# UNITED STATES PATENT AND TRADEMARK OFFICE

APPLICATION NO.	FILING DATE	FIRST NAMED INVENTOR	ATTORNEY DOCKET NO.	CONFIRMATION NO.
10/677,260	10/03/2003	Masahiro Tanaka	243492US2S	8734
22850	7590	12/22/2004	EXAMINER	
OBLON, SPIVAK, MCCLELLAND, MAIER & NEUSTADT, P.C. 1940 DUKE STREET ALEXANDRIA, VA 22314			NGUYEN, THINH T	
			ART UNIT	PAPER NUMBER
			2818

<b>Office Action Summary</b>	Application No. 10/677,260	Applicant(s) TANAKA ET AL.	
	Examiner Thinh T Nguyen	Art Unit 2818

### **DETAILED OFFICE ACTION**

FIG. 21

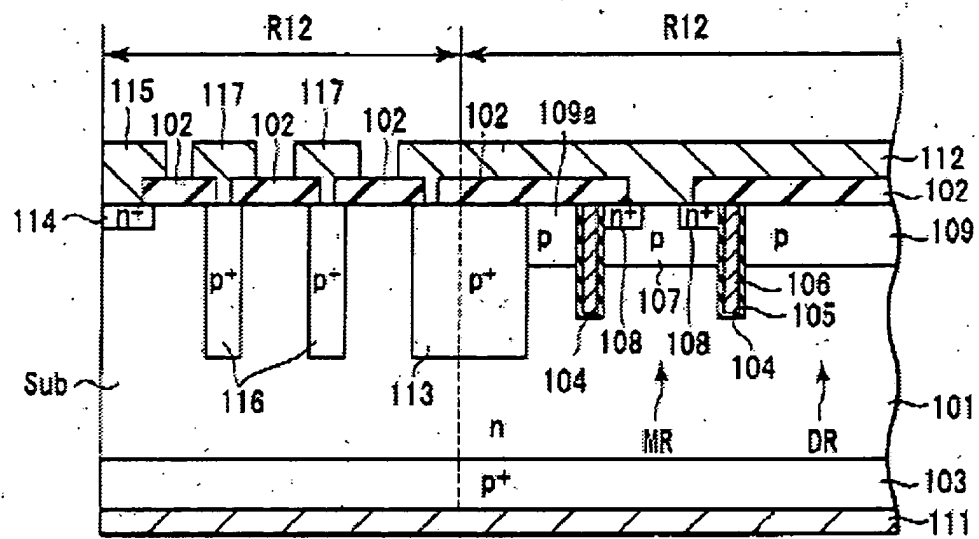
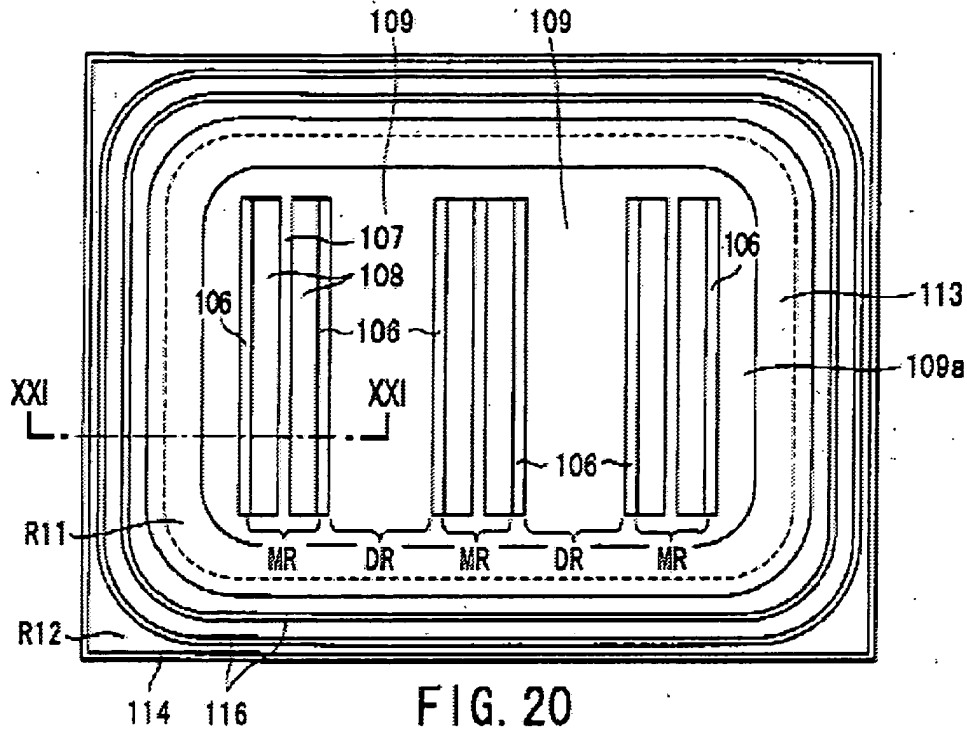
3. Fig. 20 and 21 are not designated by a legend such as "prior art". The legend is necessary in order to clarify what applicant's invention is (see MPEP paragraph 608.02).

Admitted Prior Art (the AAPA) disclosed in fig 20 and fig 21.

The AAPA discloses (fig 20, fig 21, paragraph [0008] to [0011]) a power semiconductor device comprising: a semiconductor active layer (fig 21 layer 101); a first base layer (fig 21 layer 101) of a first conductivity type disposed in the active layer; a plurality of trenches disposed in a surface of the active layer at intervals to partition a main cell and a dummy cell (fig 20), and to reach the first base layer; a collector layer (fig 21 layer 103) of a second conductivity type disposed on the first base layer, at a position remote from the trenches; a second base layer (fig 21 layer 107) of the second conductivity type disposed in the main cell and on the first base layer; an emitter layer (fig 21 layer 108) of the first conductivity type disposed on the second base layer; a buffer layer of the second conductivity type (fig 21 layer 109) disposed in the dummy cell and on the first base layer; a gate electrode (fig 21 layer 106) disposed in each trench to face, through a gate insulating film (fig 21 layer 105), a portion of the second base layer sandwiched between the first base layer and the emitter layer; a collector electrode (fig 21 layer 111) disposed on the collector layer; an emitter electrode (fig 21 layer 112) disposed on the second base layer and the emitter layer; and a partition structure (fig 20, fig 21) disposed in the surface of the active layer to electrically isolate the buffer layer from the emitter electrode.

The AAPA ( fig 20,fig 21) discloses a power semiconductor device wherein the partition structure that comprises: a partition wall ( fig 21 layer 105) formed of a partition trench disposed in the surface of the active layer.

The AAPA (fig 20,fig 21) discloses a power semiconductor device wherein the partition trench has a depth substantially the same as the trenches.

The AAPA (fig 20,fig 21) discloses a power semiconductor device wherein a conductive layer (fig 21 layer 106) is disposed in the partition trench and wrapped in an insulating film and wherein the conductive layer is electrically connected to the gate electrode paragraph [0009] line 6.

The AAPA (fig 20,fig 21) discloses a power semiconductor device wherein the partition trench is filled with an insulating layer (fig 21 layer 105).
